UNITED STATES PATENT AND TRADEMARK OFFICE

APPLICATION NO.	FILING DATE	FIRST NAMED INVENTOR	ATTORNEY DOCKET NO.	CONFIRMATION NO.
10/803,474	03/17/2004	Stan Cheng		5465

Office Action Summary	Application No. 10/803,474	Applicant(s) CHENG, STAN	
	Examiner Philip Gabler	Art Unit 3637

DETAILED ACTION

Exhibit 1: Jeong '624 Figures 1 and 4C

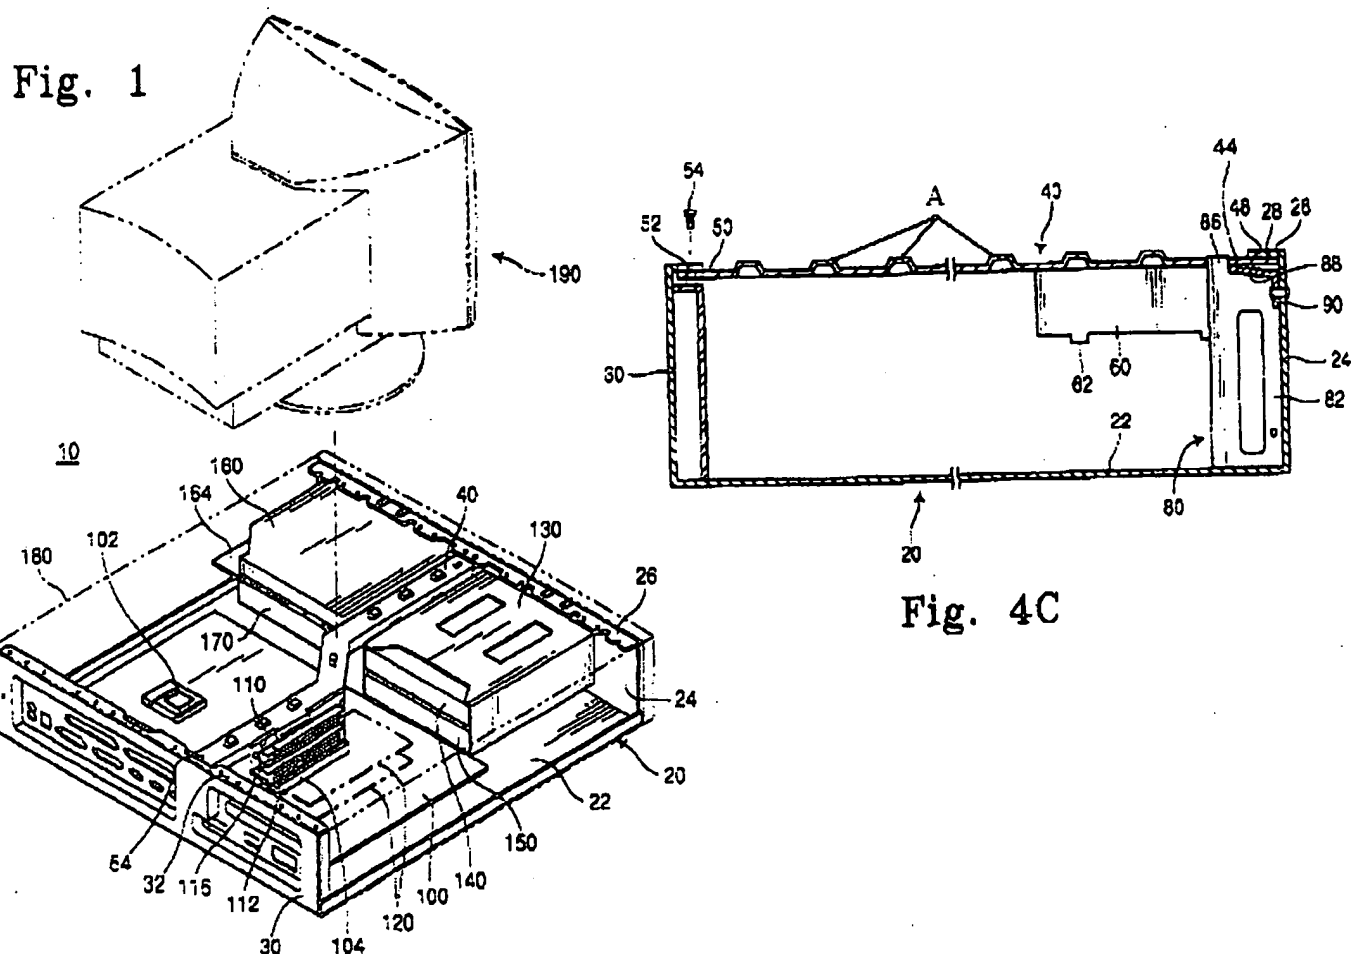
3. Regarding claims 1, 2, 9, and 13, Chang (Figure 1) discloses a chassis apparatus usable with a computer comprising: a chassis frame (2, including 5, 24, etc.) comprising a set of load-bearing rails (5, portions of 24) located on edges of the frame; and a plurality of protrusions (51, 241) formed on tops of the load-bearing rails, and to laterally secure a removable structure (6) to the chassis frame by coupling the protrusions with portions (60) of the structure formed to be secured thereover, the removable structure configured to be capable of housing at least one small form factor computer component (element 6 is a drive holder). Chang does not disclose the protrusions as supporting a chassis cover (which is present as element 1). Jeong (Figures 1 and 4C) discloses a computer chassis apparatus including a load-bearing surface (upper surface of 40) including protrusions, or means for supporting a chassis cover, (viewed as A in Exhibit 1) configured to support a chassis cover (180). [See

Figure 4C and column 4 lines 2-7 for disclosure of 40 (and protrusions A) acting as a support for the cover, monitor, etc.] Accordingly, it would have been obvious to one of ordinary skill in the art to replace Chang's protrusions with Jeong's protrusions (i.e. domes which would engage the cover in place of hooks that do not) because this arrangement would provide additional strength and support to the chassis apparatus by better supporting the cover while still securing the removable structure (the holes of the removable structure would be fitted over and around the protrusions, laterally securing the structure in at least two directions).

4. Regarding claim 4, Chang and Jeong further disclose flat-topped protrusions (see figures).
5. Regarding claims 5 and 6, Chang and Jeong further disclose protrusions which are mounted to and integrally formed with the load-bearing rails.

6. Regarding claim 10, Chang further discloses the portions of the structure comprise protrusions corresponding to the protrusions of the chassis frame (portions of protrusions 60 mate with the protrusions of the frame).

7. Regarding claim 14, Chang discloses a computer chassis apparatus comprising: a computer chassis frame (2, including 5, 24, etc.) for a form factor computer comprising at least two upward facing surfaces (upper surfaces of 5 and 24); a plurality of oblong rounded structures (51, 241) formed into the upward facing surfaces of the computer chassis frame and distributed along the surfaces; a removable drive frame (6) capable of supporting a plurality of drives of different sizes adapted to be installed within the computer chassis, the removable drive frame comprising interface structures (601)
